Original approved drawing by Conran + Partners.

Drawing revised by HGP in areas to indicate proposed amendments

Date	Feb 2021
Drawn By/Checked By	RW/VC
Scale	1:250@A1
Revision	**P4**
Project	**Kingston Wharf Brighton**
Title	**Proposed South Elevation (Sheet 2)**
Dwg #	**20086-HGP-PL-502**
Status	**PLANNING**

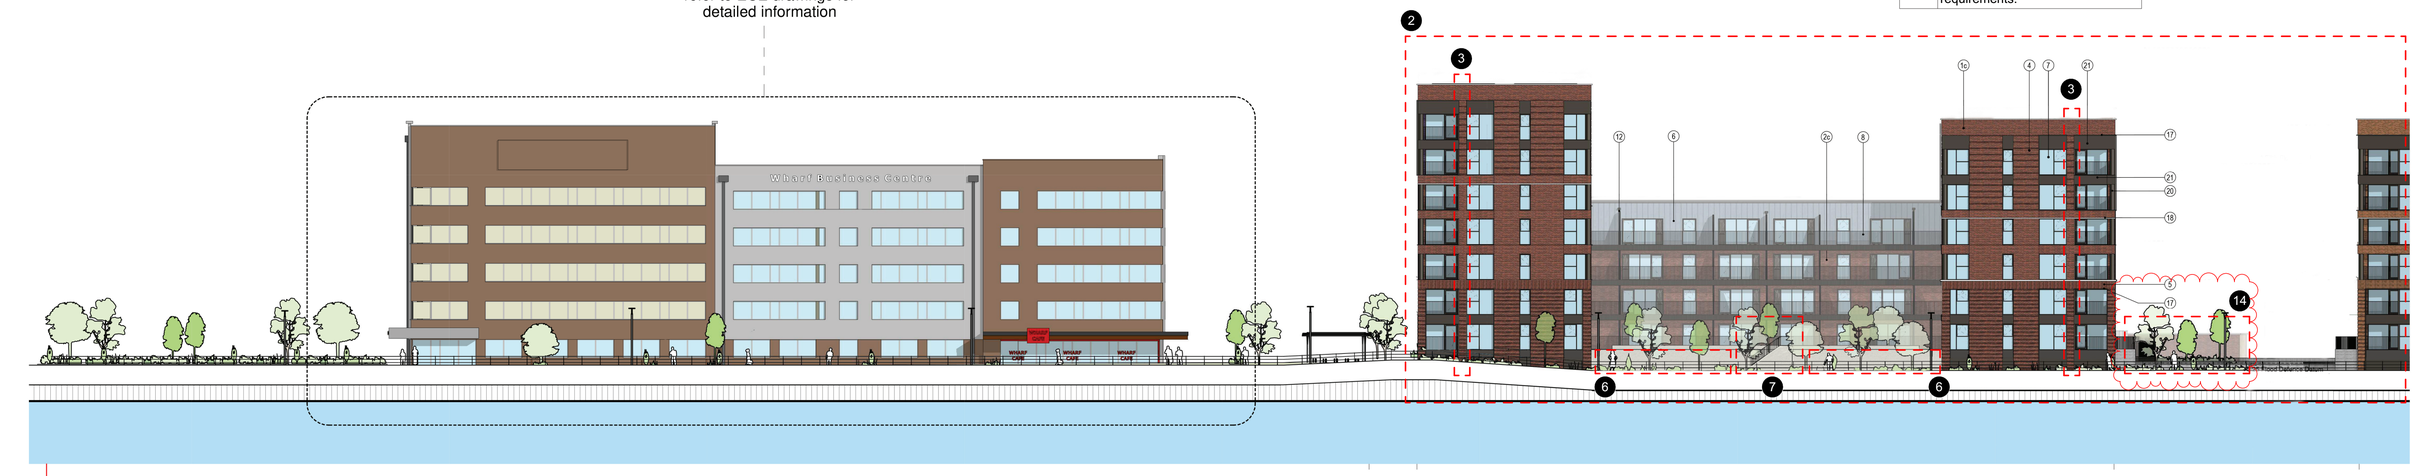
1 Levels amended to suit reduction in building height.

2 Building height reduced and basement raised out of tidal zone to mitigate the risk of flooding.

3 Brick piers introduced to provide secure junction to window & baustrade fixing.

4 Window positions revised to suit structural requirements.

5 Windows replaced with tax windows to meet fire strategy compliance.

6 Ventilation grilles removed to avoid sea water exposure to basement.

7 External stair as additional means of escape added to meet fire strategy compliance.

8 Cores revised to meet fire strategy compliance.

9 Sprinkler tank added to meet fire strategy compliance.

10 Parking layout amended to suit basement changes.

11 Wall alignment amended to facilitate basement structure and sea wall requirements.

12 Seating alcove adjusted to suit structural requirements and to provide additional space for sprinkler plant room in the basement.

13 Plant and store room doors to open externally to meet fire strategy compliance.

14 Substation size amended to meet servicing strategy.

15 Glass door replaced with solid door to meet fire strategy compliance.

16 Ramp extended to suit change in levels and artwork added to soften street scene
